REMARKS

These remarks are submitted in response to the Office Action of March 24, 2003. In the Office Action, the Examiner objected to the drawings under 37 C.F.R. § 1.83(a) and objected to the specification as being unclear. The Examiner rejected claims 1-3, 6-11, 15-18, and 20 under 35 U.S.C. § 102(b) as being anticipated by U.S. Patent 3,316,950 to Fleischer et al. ("Fleischer"). The Examiner also rejected claims 1-6, 9-12, 14-16, 18, and 21 under 35 U.S.C. § 102(e) as being anticipated by U.S. Patent 6,485,177 to Bell ("Bell"). The Examiner also rejected claims 3 and 4 under 35 U.S.C. § 103(a) as being unpatentable over Fleischer in view of U.S. Patent 6,076,968 to Smith et al. ("Smith"). Finally, the Examiner rejected claims 13 and 19 under 35 U.S.C. § 103(a) as being unpatentable over Fleischer in view of U.S. Patent 6,270,255 to Kaufman et al. ("Kaufman").

FIG. 1

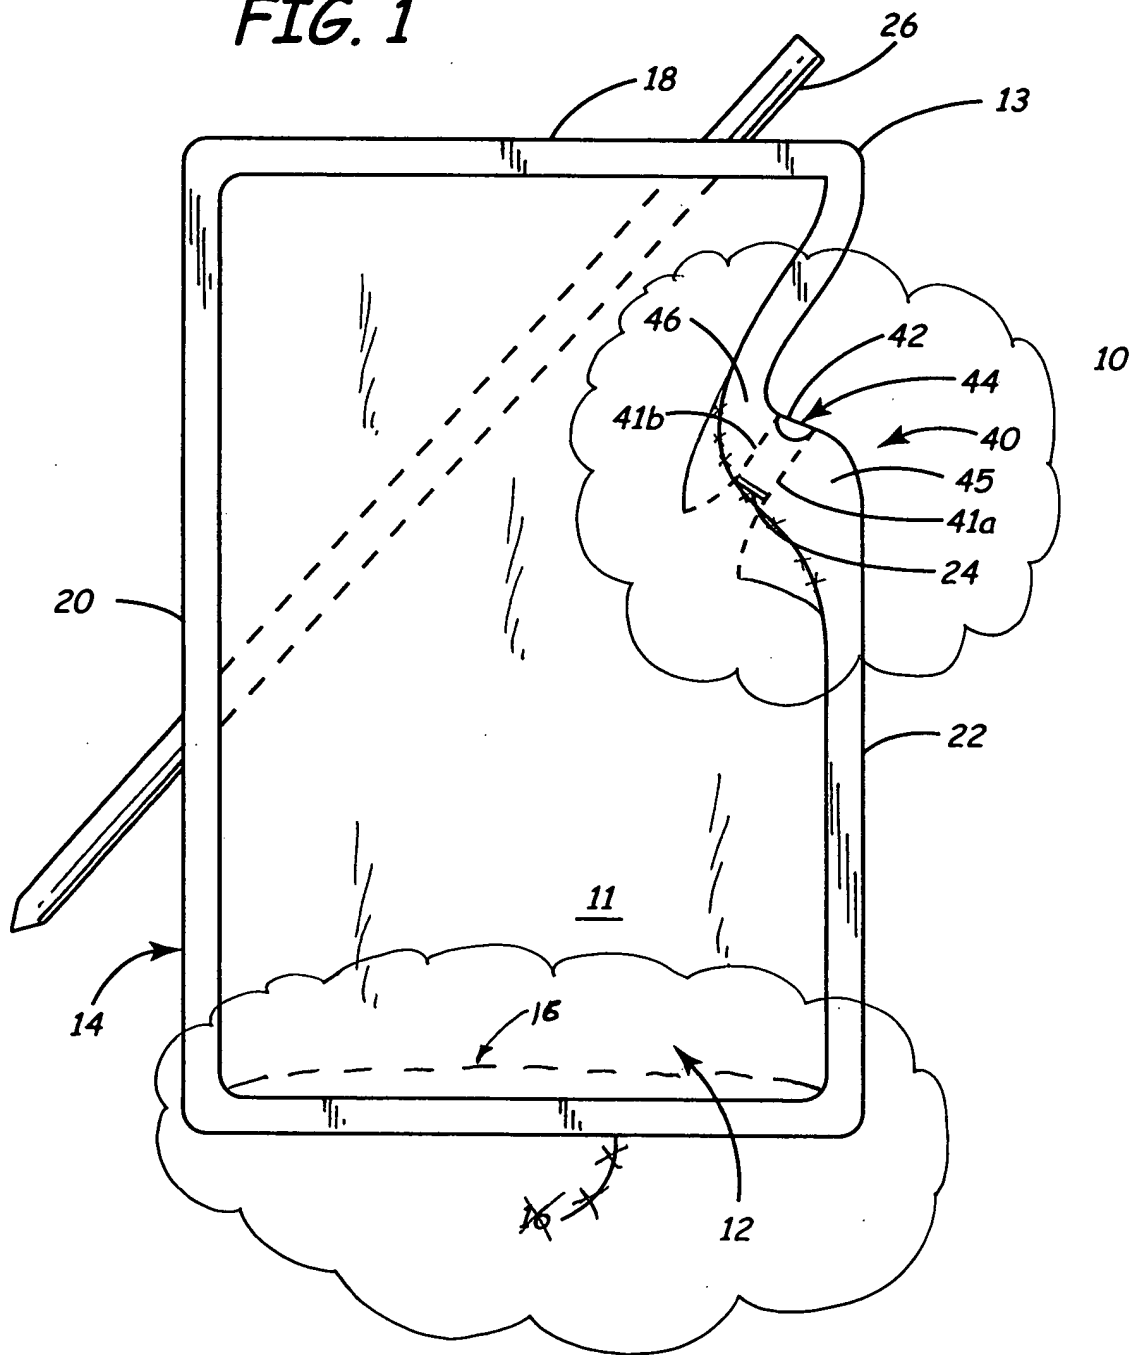
In the Office Action, the Examiner objected to the drawings under 37 C.F.R. § 1.83(a) as failing to illustrate a third panel having a gusseted bottom, as recited in claim 14. Applicants have added a hidden line at the bottom of FIG. 1 and repositioned the reference number "16" that references the third panel 16. Support for this amendment can be found at page 3, line 25 of the specification as filed, which reads, "[t]he first panel 12 and the second panel 14 are further affixed to the third panel 16 so that the third panel 16 forms a gusseted bottom between the first and second panels 12 and 14." Applicants respectfully submit that no new matter has been added and the amendment obviates the objection.

In the Office Action, the Examiner objected to FIG. 7 as being unclear because it illustrates piercing point 24 as being located in a portion of the bag that is not part of the seam. Also, the Examiner objected to the written description as being unclear with respect to the column extension recited on page 5, lines 16-18.

To clarify the drawings so they more fully correspond to the specification, Applicants have amended FIGS. 1 and 7. Specifically, the hidden lines 41a, 41b that define the column have had their ends joined to the seal 13 between the first and second panels 12, 14, thereby forming the areas 45, 46 that have “a wider seal 13 between the first panel 12 and second panel 14.” *Specification as filed, p. 5, ll. 10-14.*

The specification states, “[s]ides 41a and 41b of the column 40 help to guide the piercing straw 26 to the piercing point 24 without snagging or damaging the interior of the column 40. Furthermore, as illustrated in FIG. 1, sides 41a and 41b of the column 40 may extend further beyond the piercing point 24 to guide the straw 26 into the compartment 11 even after piercing the piercing point 24.” *Specification as filed, p. 5, ll. 14-18.* Also, “[w]hen the straw 26 is utilized to pierce the piercing point 24, it does not actually pierce through one of the laminate 17 layers, but actually separates the sealed together panels 12 and 14.” *Specification as filed, p. 6, ll. 9-11.* Finally, “[a]s illustrated in FIG. 7, the column 40 may further include a second piercing point 52. The second piercing point 52 may be utilized as a second barrier between the exterior of the pouch 10 and the compartment 11. The second piercing point 52 may be formed in substantially the same manner as piercing point 24.” *Specification as filed, p. 8, ll. 22-25.* Thus, as is clear from the specification as filed, and as note by the Examiner, that the column is defined by the gap in seam 13. Therefore, it is proper to show the ends of hidden lines 41a, 41b (i.e., the lines that define the gap in seam 13) connected to the line forming the wider seam 13 between the first and second panels 12, 14 at the wide areas 45, 46. Thus, Applicants respectfully submit that the amendments to FIGS. 1 and 7 have obviated the objections and have added no new matter.
